# REMCOR<sup>®</sup>

## LPSID350/150

### B.P. Oil Service Sentinel

June 1992

#### ITEM (1) DRAIN COLLECTOR ASSEMBLY

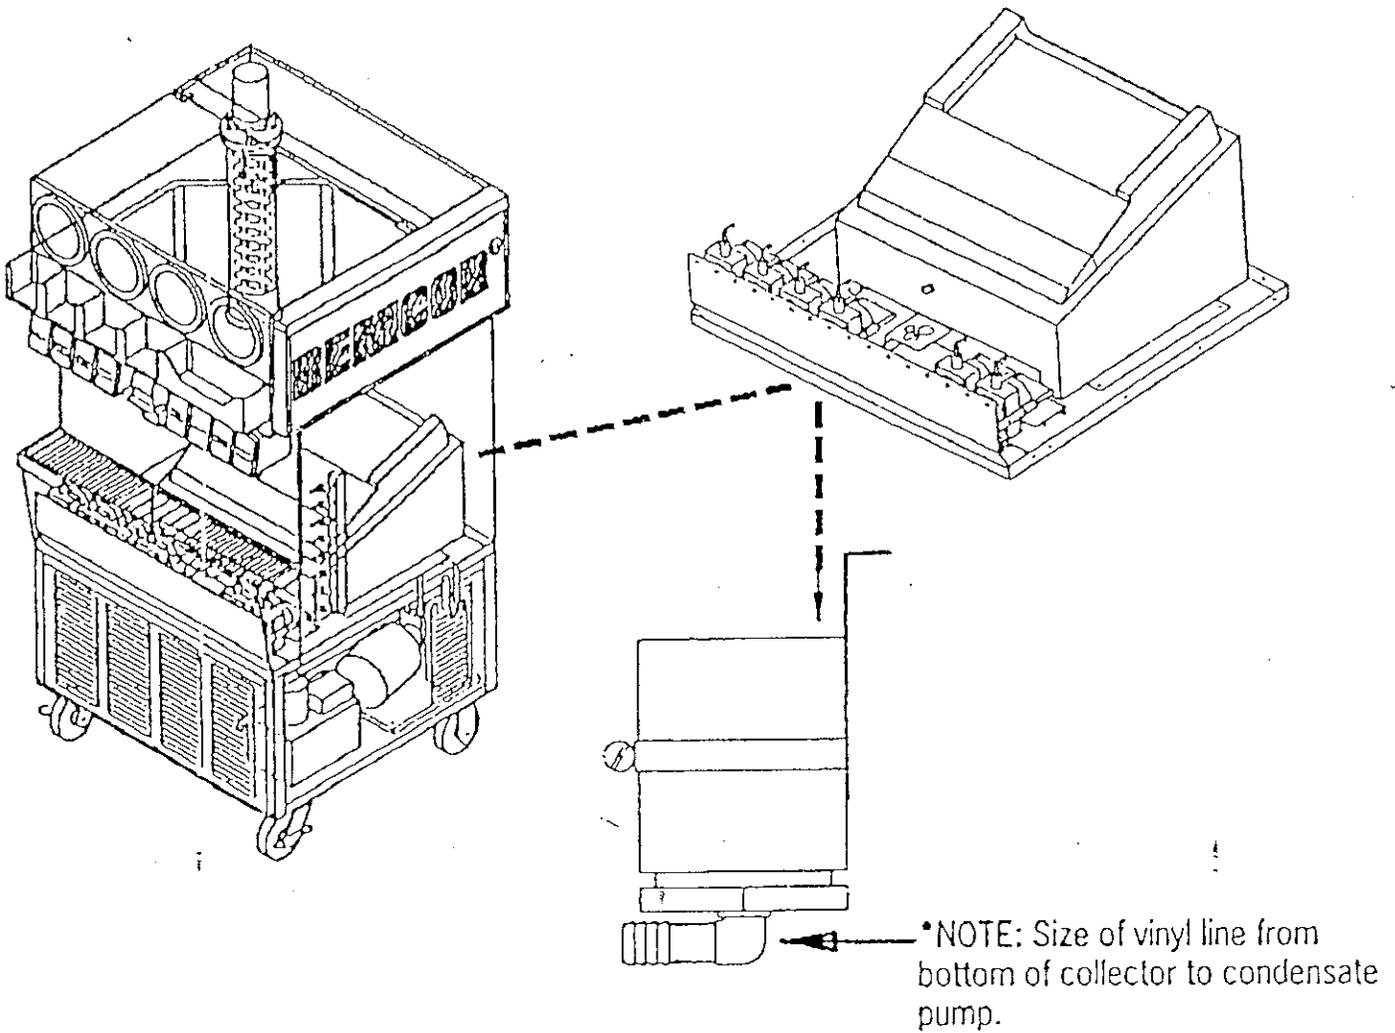
A 2-1/2" pvc fitting that the three (3) vinyl lines from the cold plate drain, drip tray line and icemaker purge line drain into.

\*Serial numbers 6603 to 7280 will use a half-inch line from collector to condensate pump.

\*All LPSID350 units after serial number 7280 are built with a one-inch line from collector to condensate pump.

All units built before serial number 7280: If erratic overflowing of collector occurs, it may be necessary to replace 1/2" line collectors with one-inch line collectors, part number 02223.

ITEM (3)

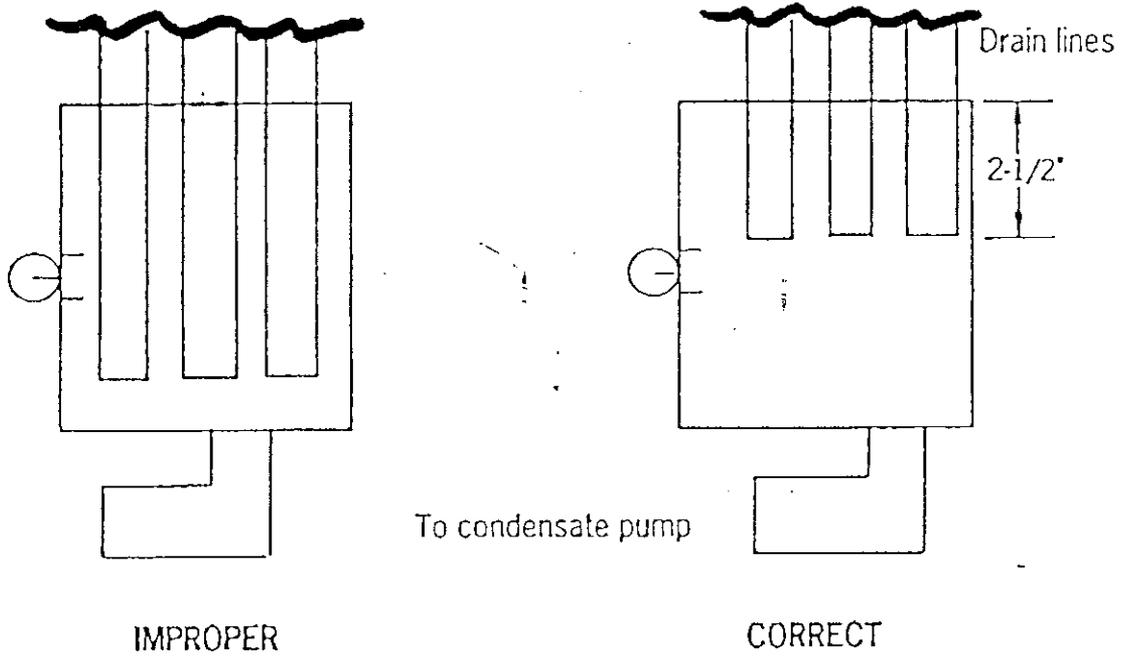
Check the height of the collector and lines going into the collector.

\*The collector must be mounted as high as possible to allow for proper pitch of the drain line to the condensate pump on existing installations and new installs of collector kits, #02223 (ITEM (1)).

\*The three (3) lines from the cold plate drain, drip tray drain and icemaker purge must not extend into the collector further than 2-1/2". If the lines extend to the bottom of the collector cup, the volume of water that the cup holds will be reduced.
